**Responses to items of December 14, 2015 Planning Commission Meeting  
By 1509 El Camino LLC, Project Sponsor  
May 3, 2016**

**1509 El Camino Real**

## Meeting Minutes Planning Commission

- b. 1509 El Camino Real, zoned R-2 and R-3 - Application for Mitigated Negative Declaration, General Plan Amendment of a portion of the site from Medium Density to Medium High Density Residential, Rezoning of a portion of the site from R-2 to R-3, Condominium Permit and Lot Combination for a new three-story, 10-unit residential condominium with at-grade parking (1509 El Camino LLC, applicant and property owner; Rodrigo Santos, engineer) (205 noticed) Staff Contact: Ruben Hurin

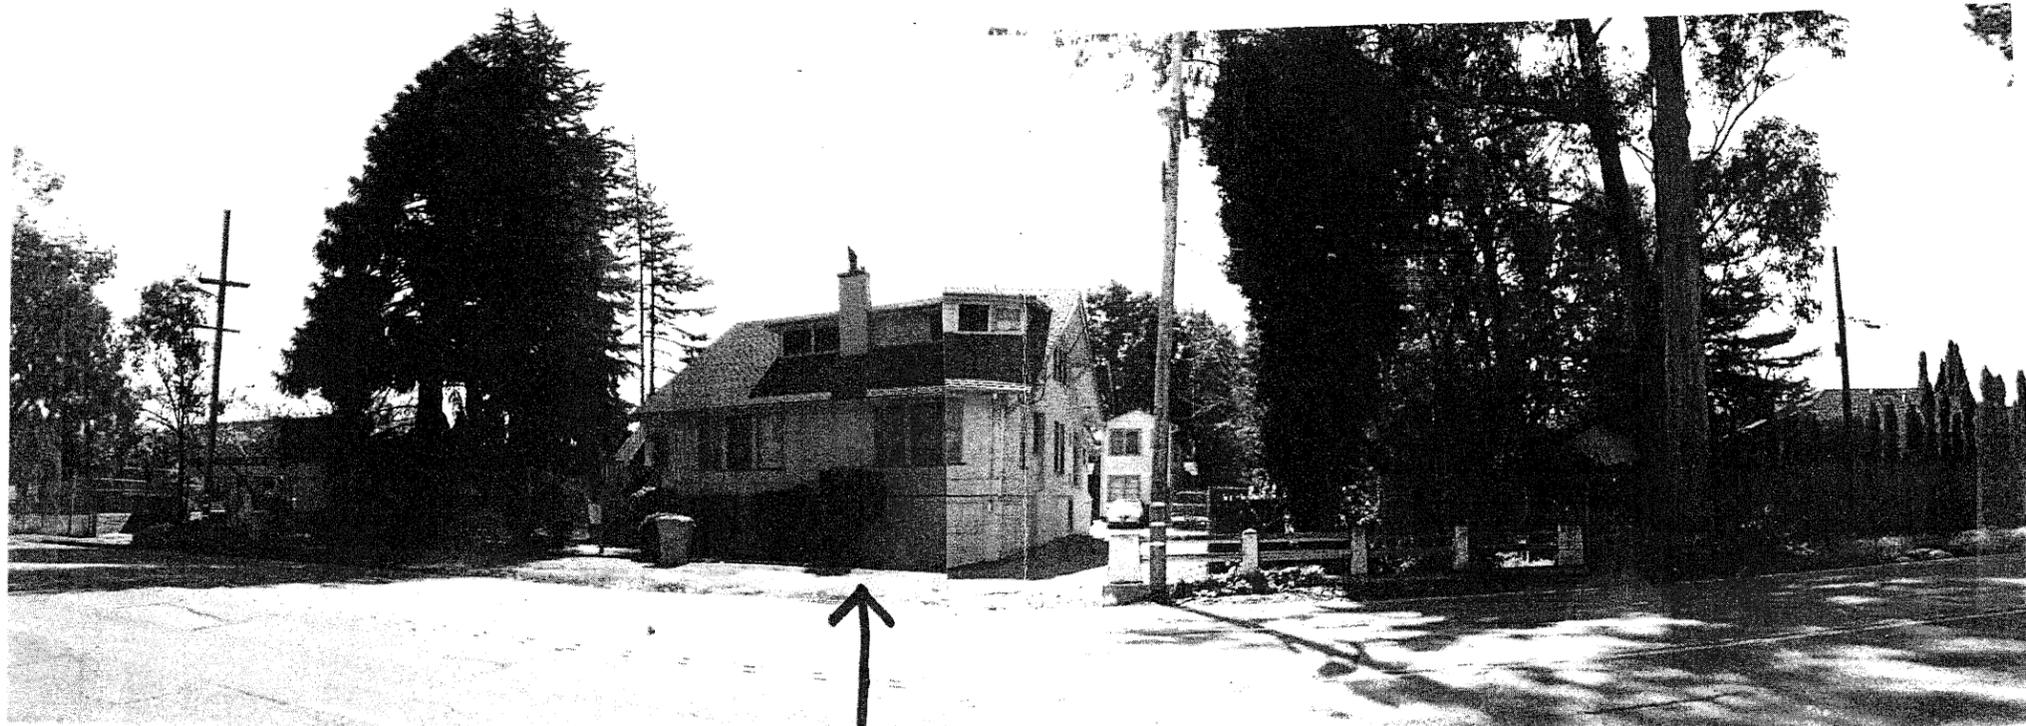
The proposed fence at the rear property was requested by the neighbor directly behind our property to provide her more privacy. She also met with Ruben Hurin and the City Arborist to discuss the matter and came up with the plan we have now. It is her desire to have the fence as an 8ft CMU wall with a stucco application along with a 2ft wood trellis above--for a total of 10ft in height. In addition to this fence, the rear property line area will include existing and new trees, and numerous shrubs to provide screening of the new building. As such, this fence proposal is fully supported and requested by the surrounding neighbors.

**b. Explain why the application request will not create a public hazard and will not be detrimental to public health, safety and general welfare.**

Since the fence is located at the rear property line which abuts to the rear yards of the property owners on Balboa Street, it is not visible to the public nor facing a street. No house or public parks, open spaces are within the immediate position of this fence so it does not create a public hazard, nuisance, or safety issue.

Tree Location Map

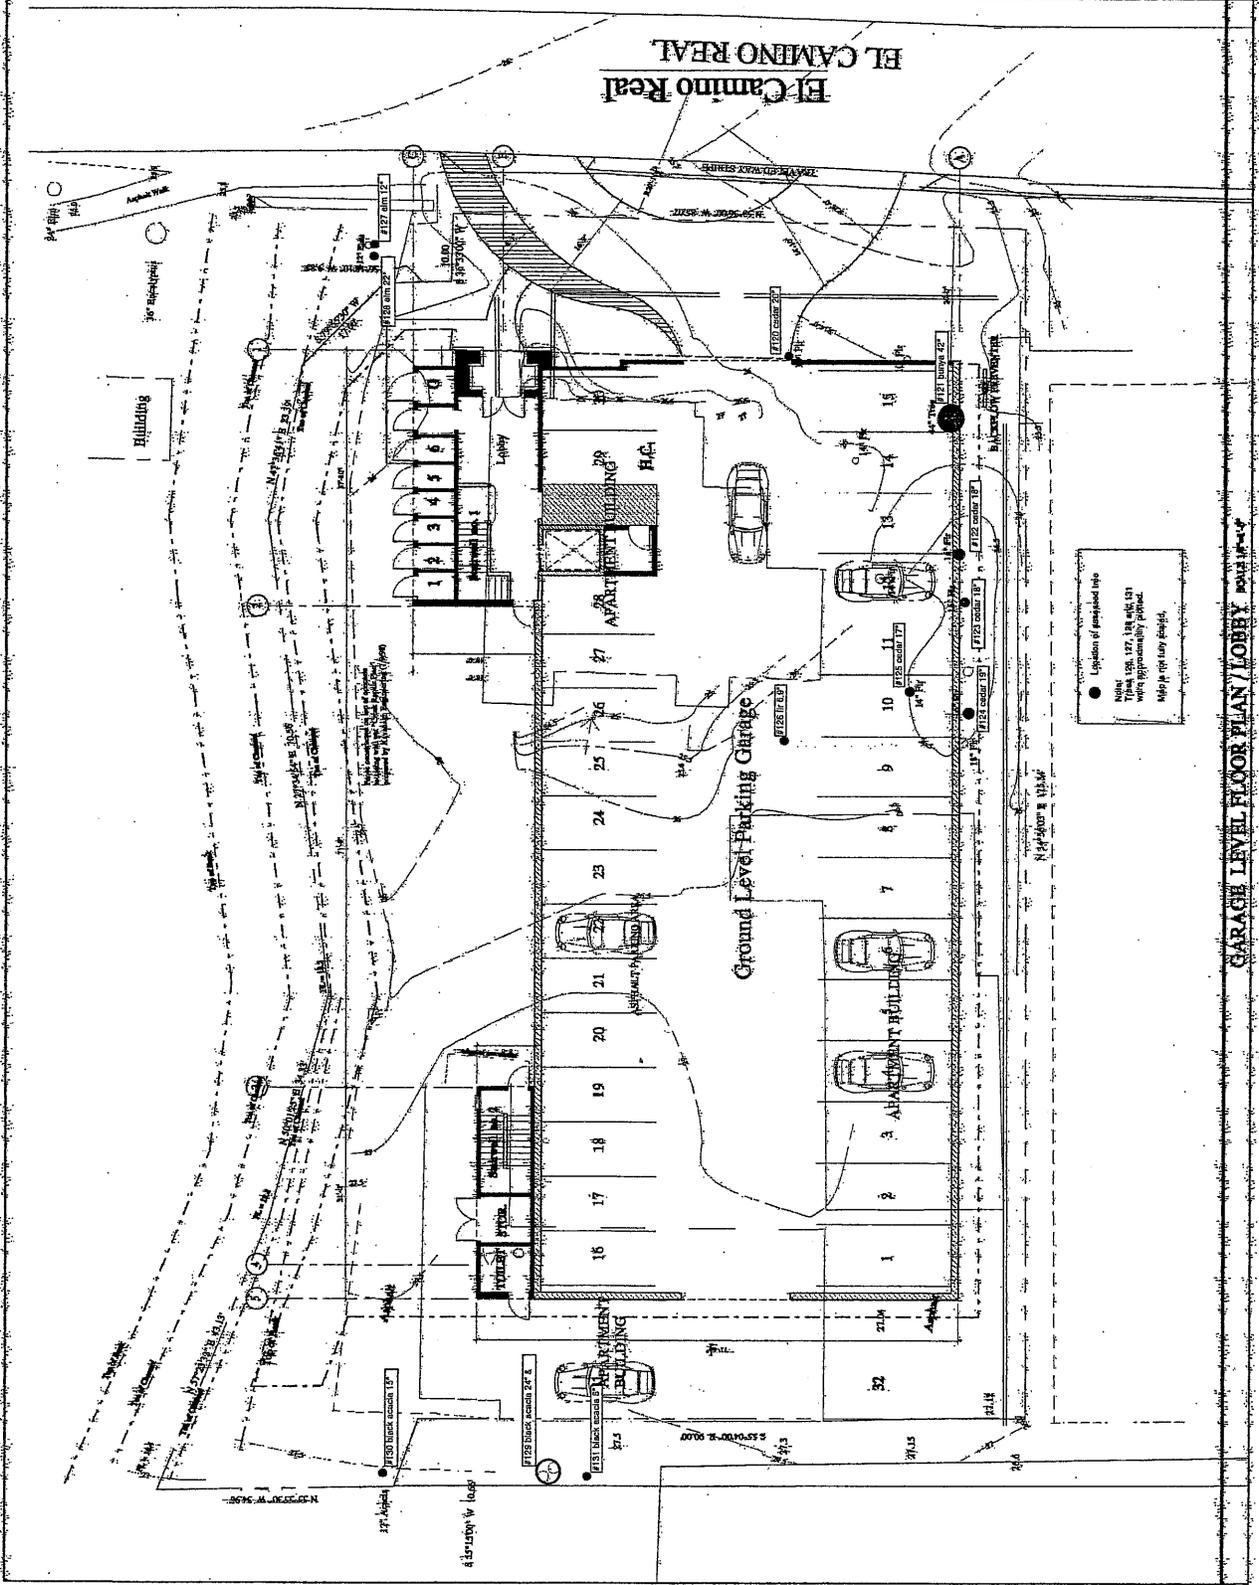
Based on the site plan provided to ROC by the client, the location of the protected trees 120 through 125 within or adjacent to the proposed structure prevents their preservation. Performing the necessary excavation, grading and related construction activities in the presence of these trees presents a hazardous situation.
